# Technical Bulletin

Bulletin Number: 470 Revision Number: R-00

**SUBJECT:** DUAL DOOR ROLLER

**MODELS AFFECTED:** All Williston Built Dixie-Narco Venders

**Dual Door Roller Kit Installed**

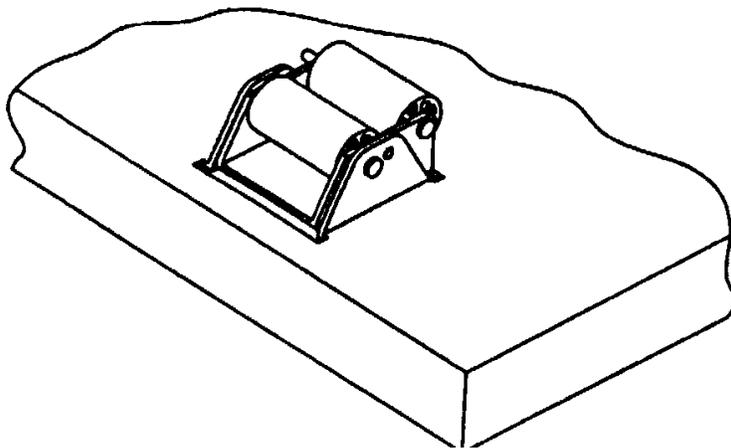
**REASON:** To provide a service kit that keeps the main door on the door roller when the main door is pushed in too far.

**ORDER:** 491,012,800.04 Dual Roller Kit
